SUBJECT: ISSUANCE OF AMENDMENTS - OCONEE NUCLEAR STATION, UNITS 1, 2,  
AND 3 (TAC NOS. M91043, M91044, AND M91045)

The amendments revise TS 3.8 to establish restricted loading patterns and associated burnup criteria for placing fuel in the Oconee spent fuel pools. In addition, the Design Features sections associated with the reactor and fuel storage are also revised.

Amendment No. 209  
License No. DPR-38

ATTACHMENT TO LICENSE AMENDMENT NO. 209

Oconee Nuclear Station  
Figure 3.5.2-16c

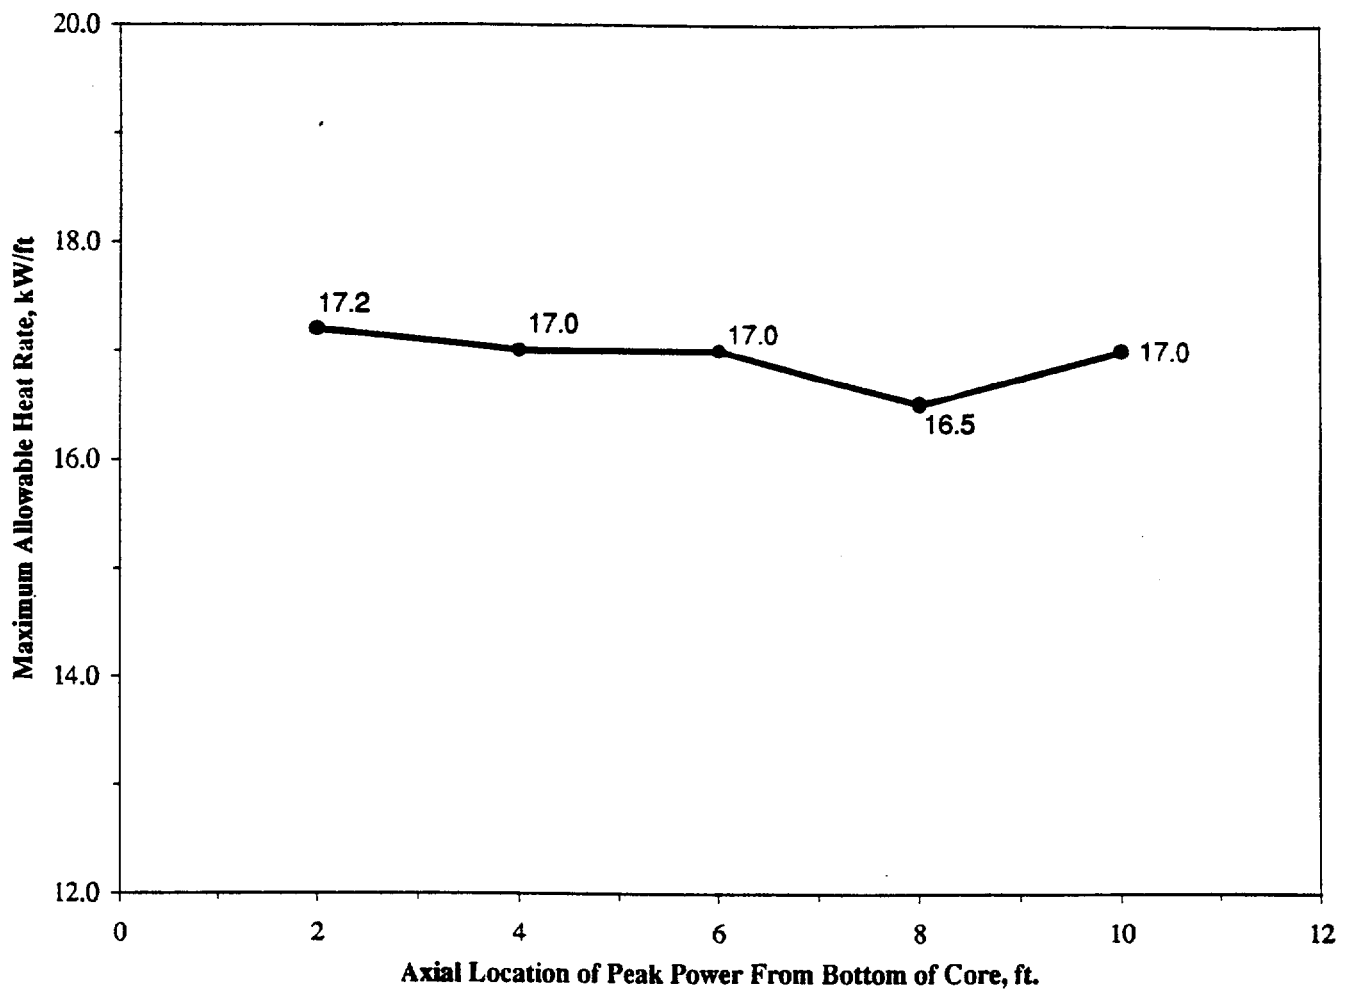
- (3) TS 3.8.17 is being added to state the required actions if the limiting conditions stated in TS 3.8.15 or 3.8.16 are not met.
- (4) The Bases is being modified to allow for specific criticality analyses for special situations without requiring additional TS changes, as described above. In addition, the Bases are being changed to address new Loss of Coolant Accident (LOCA) limits for the new MkB10T fuel assemblies.

**LOCA-Limited Maximum Allowable Linear Heat Rate For Mark-B10\* Fuel Rods,  
(BOL - 25,000 MWd/mtU)**

\* Mark-B10 fuel rods with a fuel pellet diameter of 0.3735 inches are used in the Mark B10T fuel assemblies.

Table 3.8-1

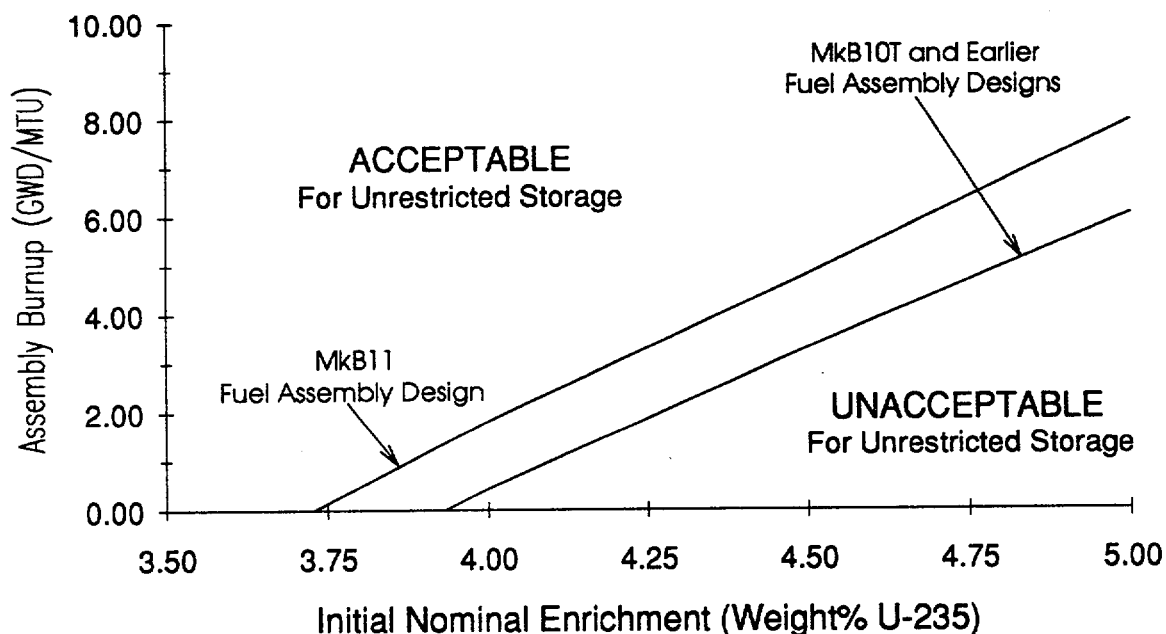
- 3.8.16 a. New or irradiated fuel may be stored in the Spent Fuel Pool shared between Units 1 and 2 in accordance with these limits:
- 1). Unrestricted storage of fuel meeting the criteria of Table 3.8-1; or

- (2) TS 3.8.16 is being added to specify the new fuel storage requirements given in Tables 3.8-1 through 3.8-4 and Figures 3.8-1 and 3.8-2 based on the reactivity analyses evaluated above.

Fuel which differs from those designs used to determine the requirements of Table 3.8-1 may be qualified for Unrestricted storage by means of an analysis using NRC approved methodology to assure that  $k_{eff}$  is less than or equal to 0.95.

Likewise, previously unanalyzed fuel up to 5.0 weight% U-235 may be qualified for Restricted storage by means of an analysis using NRC approved methodology to assure that  $k_{eff}$  is less than or equal to 0.95.

Table 3.8-3

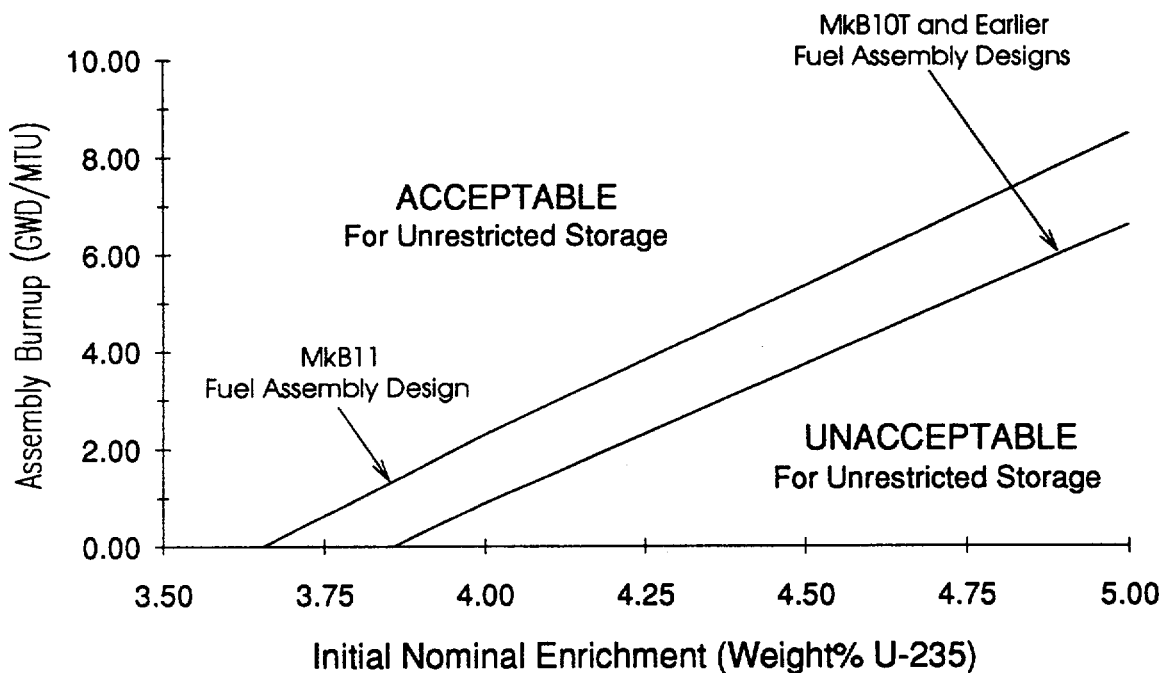
- 1). Unrestricted storage of fuel meeting the criteria of Table 3.8-3; or
  - 2). Restricted storage in accordance with Figure 3.8-2, of fuel which does not meet the criteria of Table 3.8-3.

Fuel which differs from those designs used to determine the requirements of Table 3.8-3 may be qualified for Unrestricted storage by means of an analysis using NRC approved methodology to assure that  $k_{eff}$  is less than or equal to 0.95.

Likewise, previously unanalyzed fuel up to 5.0 weight% U-235 may be qualified for Restricted storage by means of an analysis using NRC approved methodology to assure that  $k_{eff}$  is less than or equal to 0.95.

**Figure 3.8-1**  
**Required Loading Pattern for Restricted Storage**  
**in the Unit 1 and 2 Spent Fuel Pool**

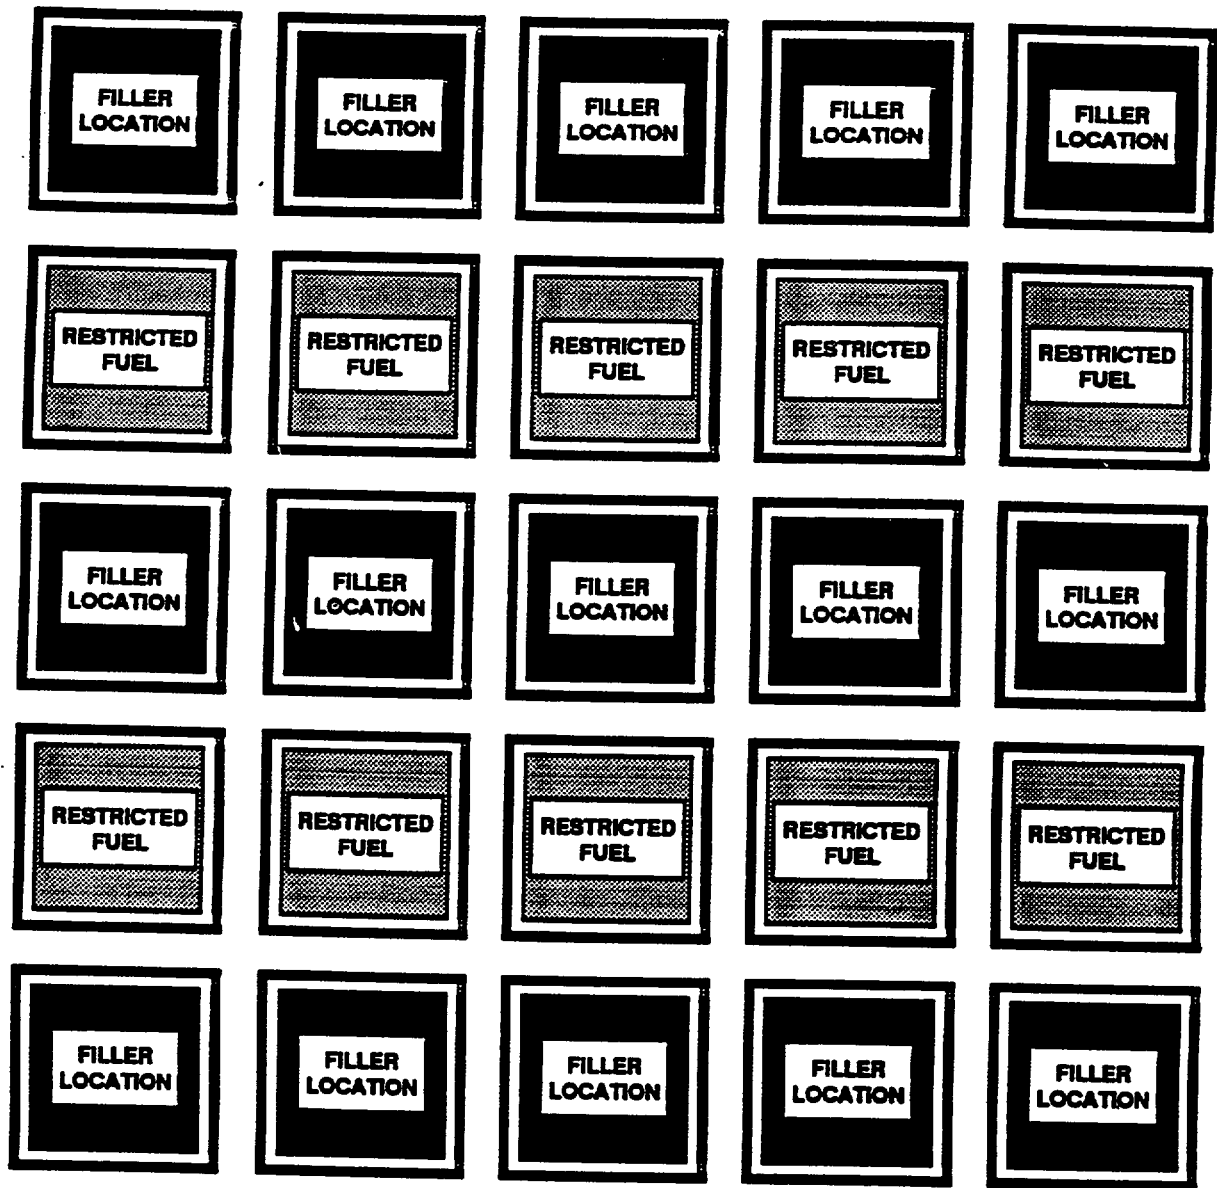
- 2). Restricted storage in accordance with Figure 3.8-1, of fuel which does not meet the criteria of Table 3.8-1.
- b. New or irradiated fuel may be stored in the Spent Fuel Pool for Unit 3 in accordance with these limits:

**Restricted Fuel:** Fuel which does not meet the minimum burnup requirements of Table 3.8-1. (Fuel which does meet the requirements of Table 3.8-1 may be placed in restricted fuel locations as needed)

**Filler Location:** Either fuel which meets the minimum burnup requirements of Table 3.8-2, or an empty cell.

**Boundary Condition:** Any row bounded by an Unrestricted Storage Area shall contain a row of filler locations (i.e. A row of Restricted fuel assemblies may not be adjacent to a row of Unrestricted fuel assemblies).
